## Subject: Hadley (Link) Smart Valve

**Models Affected: Specific model years 2024-2025 Freightliner Cascadia; and Western Star 57X vehicles manufactured October 27, 2023, through May 7, 2024.**

Daimler Truck North America LLC (DTNA), on behalf of its Freightliner Trucks Division and wholly owned subsidiary, Western Star Truck Sales Inc., is initiating Field Service Campaign SF700 A to modify the vehicles mentioned above.

Fig. 2, XMC02T Parameters Grayed Out

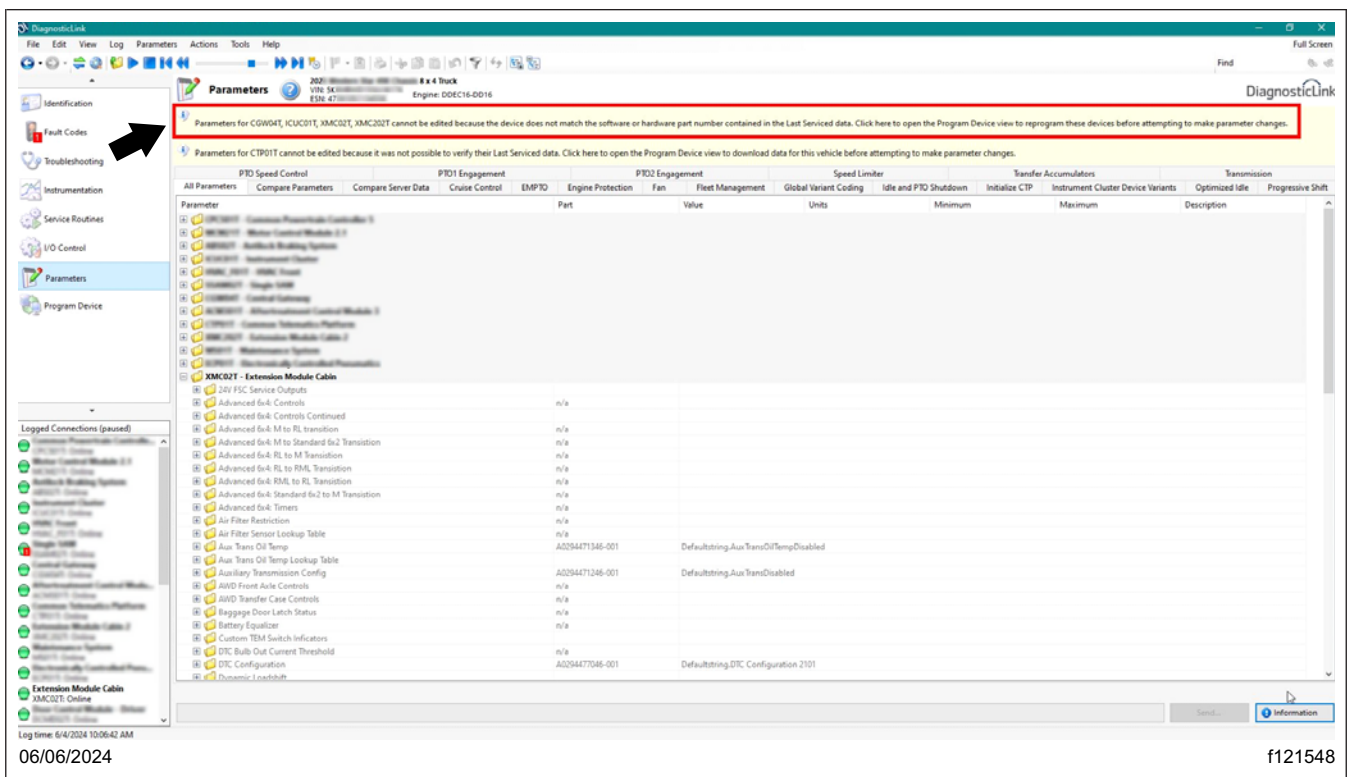
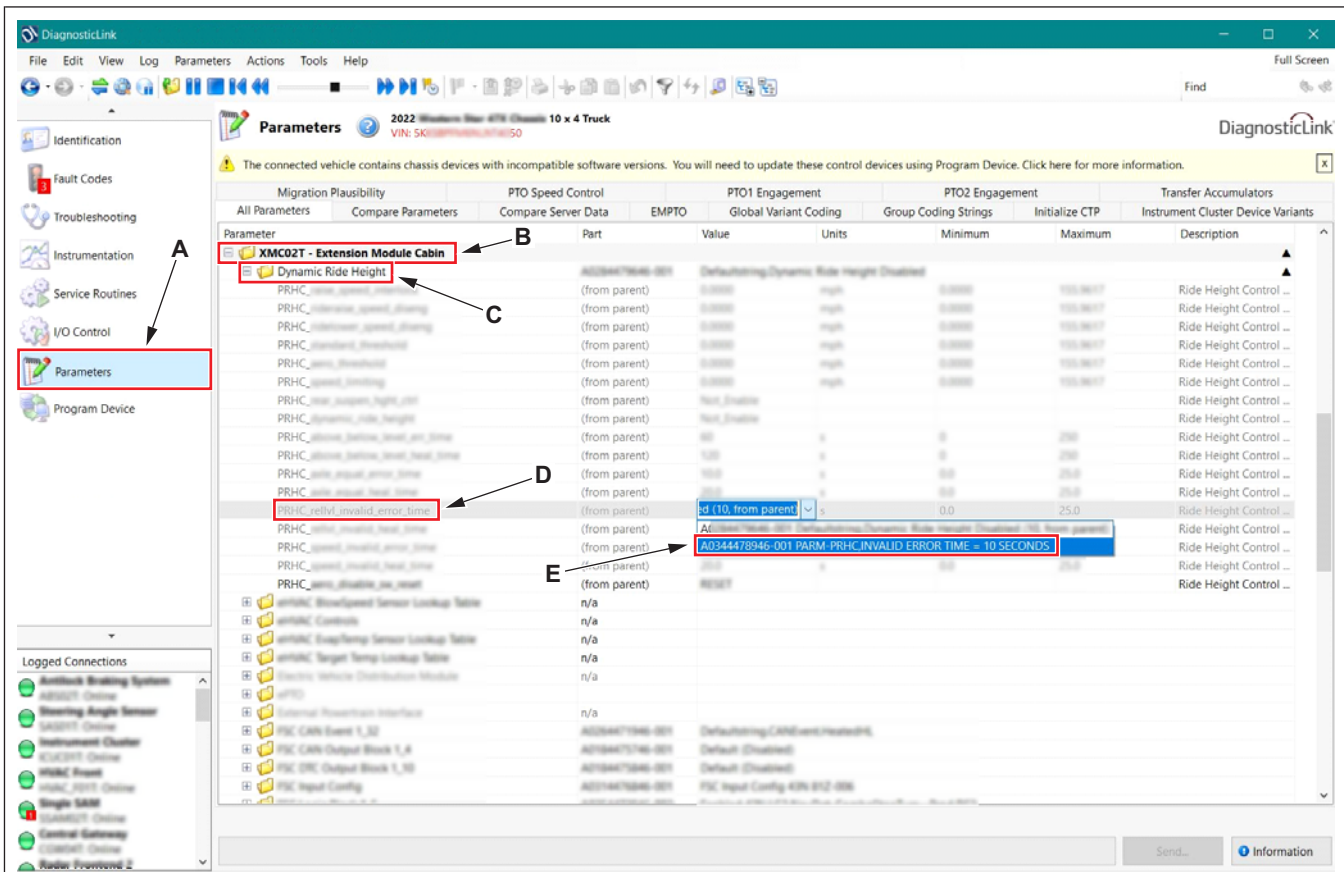
IMPORTANT: It is possible that all the parameter sub-folders within the 'XMC02T' folder are grayed out after downloading the unit data, and a banner that reads the following is displayed, as shown in **Fig. 2**.

*"Parameters for [ECUs, including XMC02T] cannot be edited because the device does not match the software or hardware part number contained in the Last Serviced data. Click here to open the Program Device view to reprogram these devices before attempting to make parameter changes."*

- This typically occurs on a new vehicle with no service record uploaded to the server. Even though the banner suggests reprogramming the listed ECUs, this is not usually necessary.
- To remedy the situation, allow the parameters to finish reading when the 'Parameters' tab is selected, then go to the 'Program Device' tab, and there should be unit data to upload. Select 'Connect to Server' to upload the data to the server, then return to the 'Parameters' tab. At this point, the XMC02T parameters should no longer be grayed out.
- If the parameter sub-folders within the 'XMC02T' folder still continue to be grayed out, programming the XMC02T to the 'Newest' configuration will be necessary to remedy the situation.
